RE: **S.A.D. 227 Lot 1, Block 2, Unit 19**
7835 Aguila St. NW
Grading and Drainage Plan
Engineers Stamp Date 4/7/19 (D10D003G1)

Based upon the information provided in your submittal received 4/19/19, this plan is approved for Grading Permit.

GRADING AND DRAINAGE PLAN
 7835 AGUILA ST NW
 LOT #1, BLOCK #2, VOLCANO CLIFFS UNIT #19

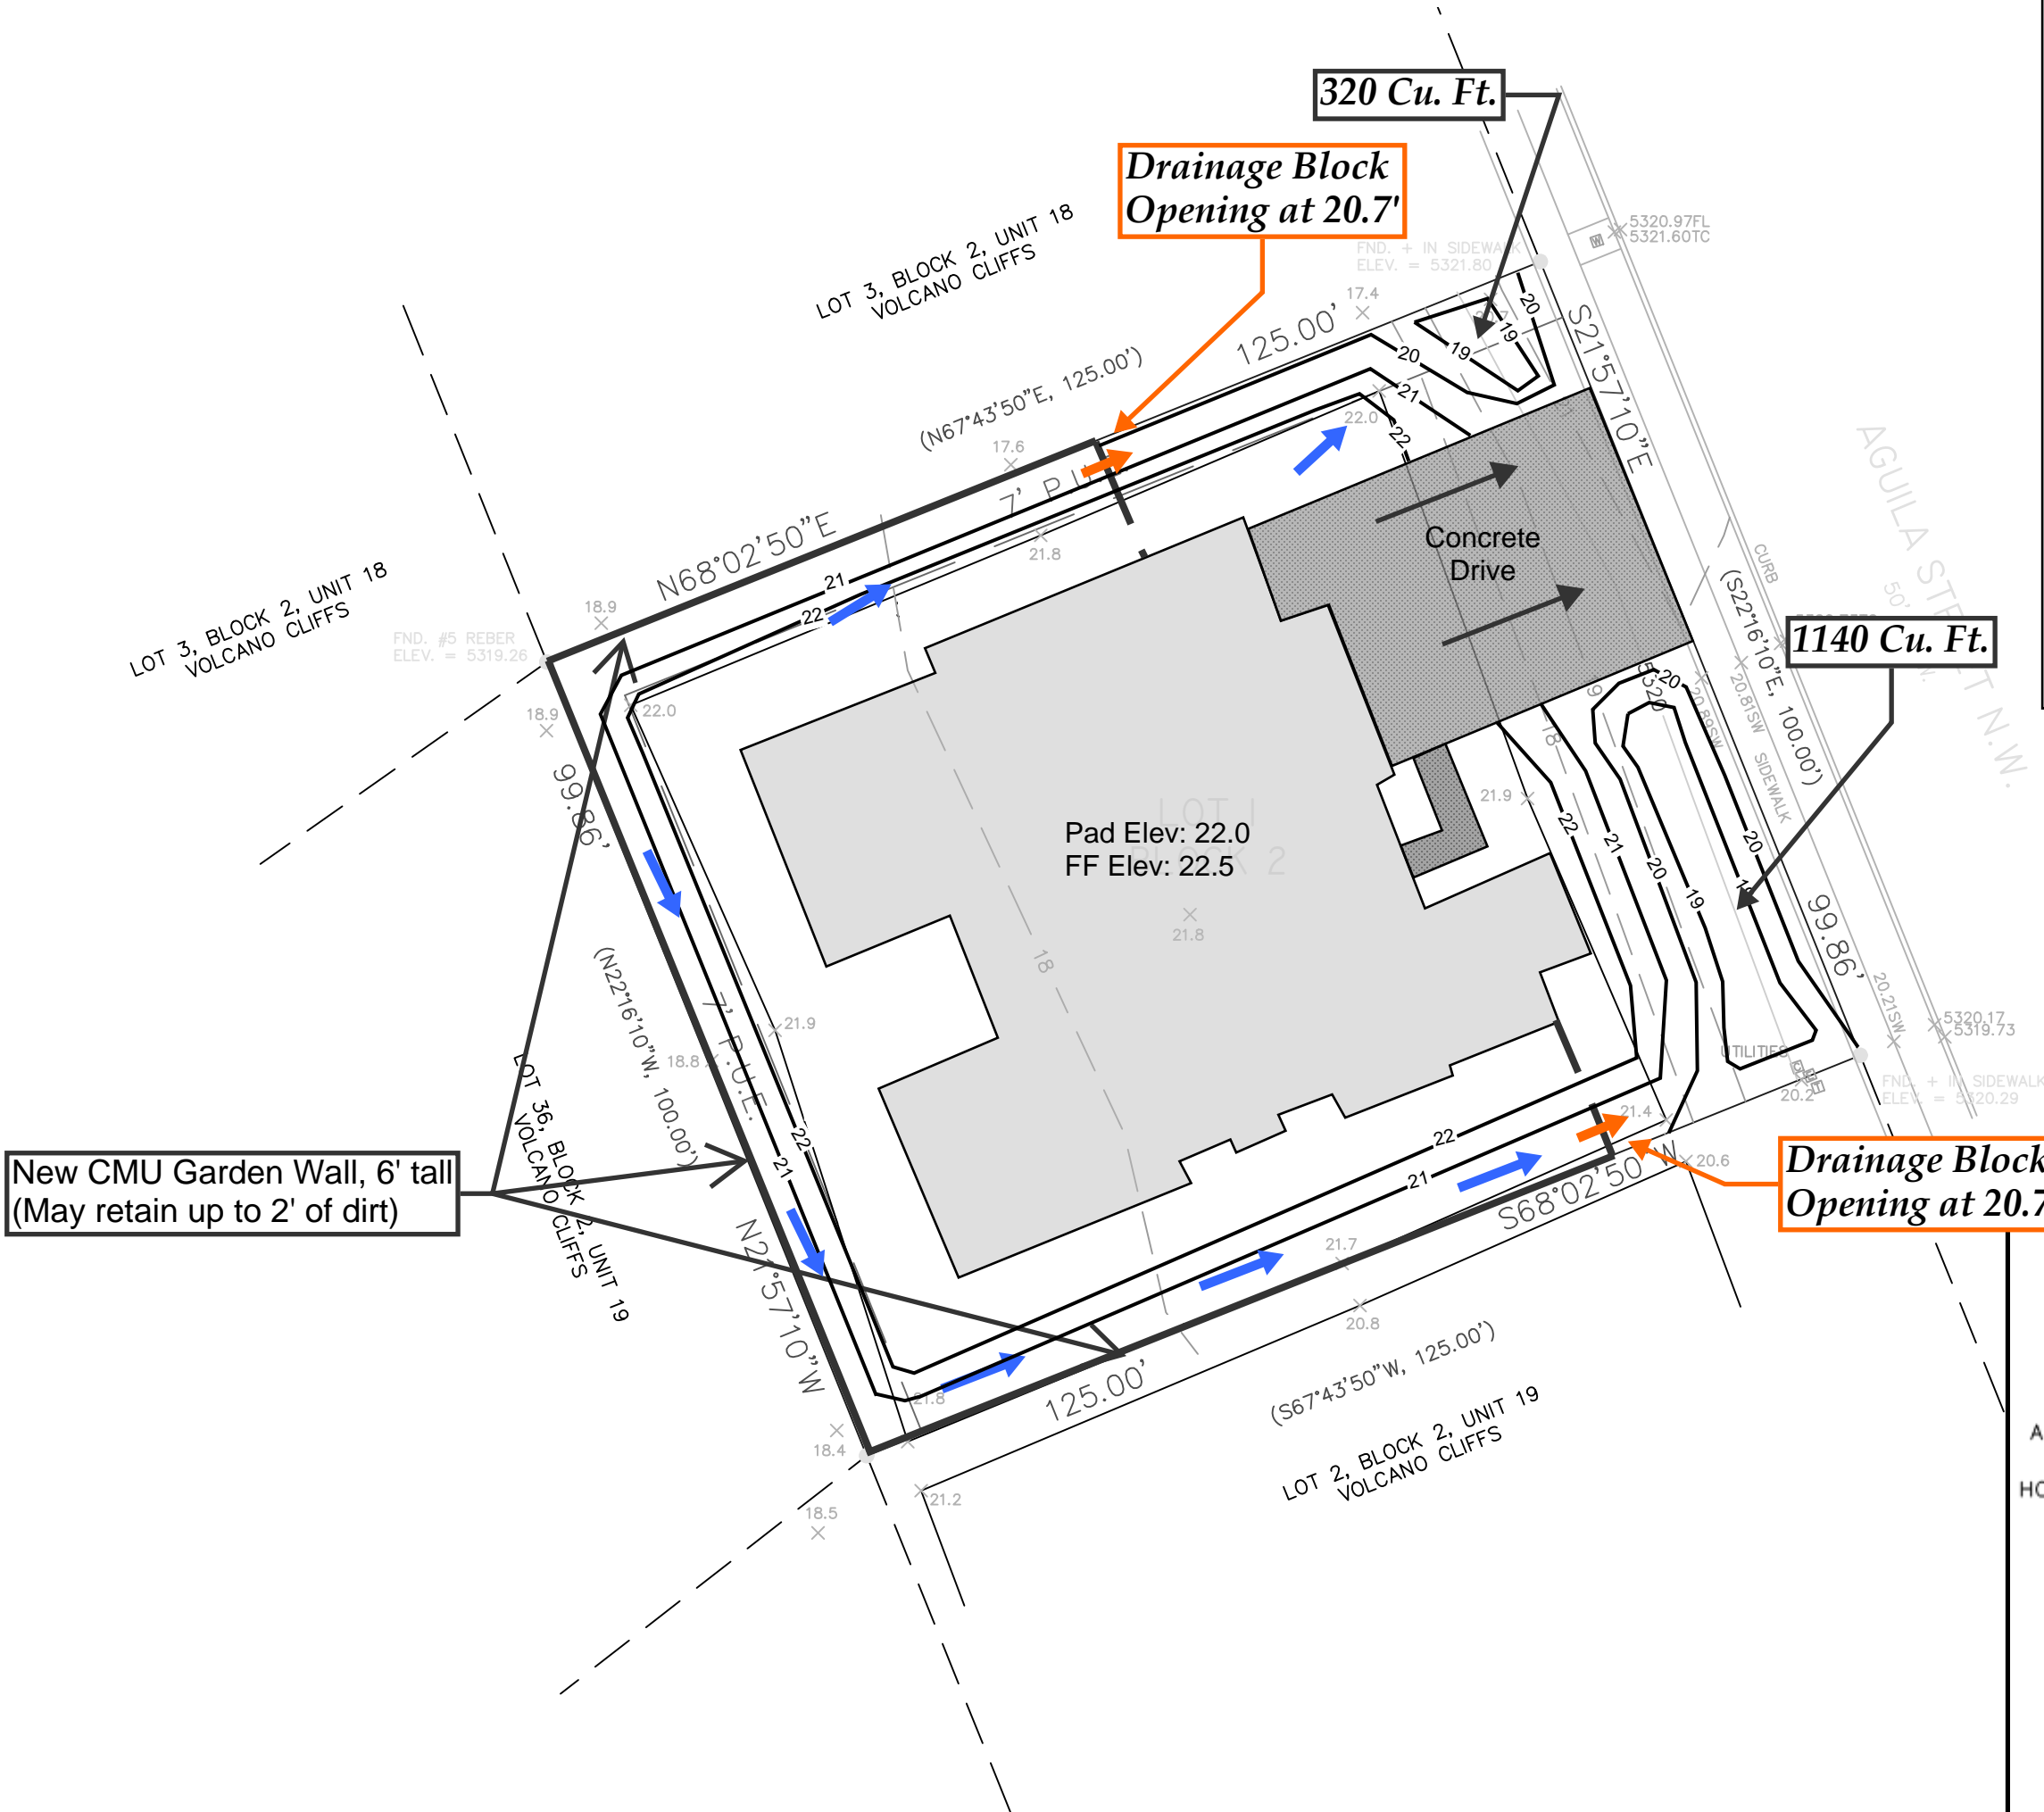
A pad certification is required before concrete is poured, either by a letter from you stating that the pad is built according to the plan submitted or by an as-built with elevations plotted.

Please attach a copy of this approved plan to the construction sets in the permitting process prior to sign-off by Hydrology. Also, please advise the owner/contractor that a separate wall permit must be obtained and this approved grading plan dated 4/7/19 must be provided with the wall permit application. Also, please advise the contractor/owner that the ponds must stay in place or CO will not be granted.

Prior to Certificate of Occupancy release, Engineer Certification per the DPM checklist will be required.
